Access Compliance Report

Public Rights-of-Way

(Pedestrian Signals)

Intersection ID: N/A	Main Street:	Cross Street: N/A	Location: N/A
ADA ID: 9E2711B83F91	Signal Type: Two Push Buttons-Non APS	Overall Compliance: No	Severity Score: BTN 1:N/A BTN 2: N/A No BTN: N/A
Codes/Mitigation Info/Possible Solution		Field Measurements/Component Compliance

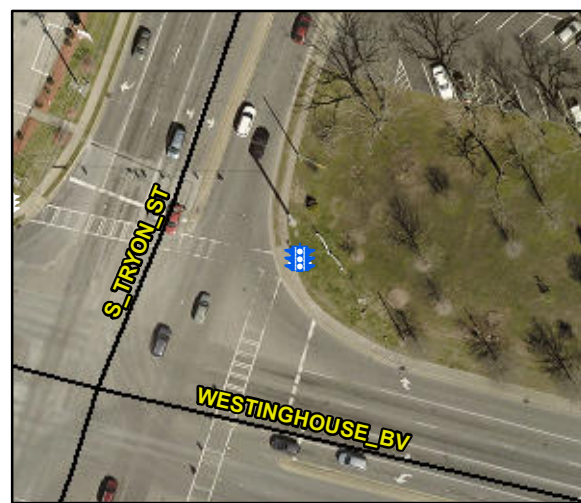
Surveyor Notes: TEXT HT 3/8

PROW/ADA: R410.6, TMUTCD 4e.08, R404.2, R404.7.3, R209.1, R406.2, R406.3, R404.7.2

Possible Solutions: Replace Signal Push Button With APS Button on New Post. Remove & Replace Sign.
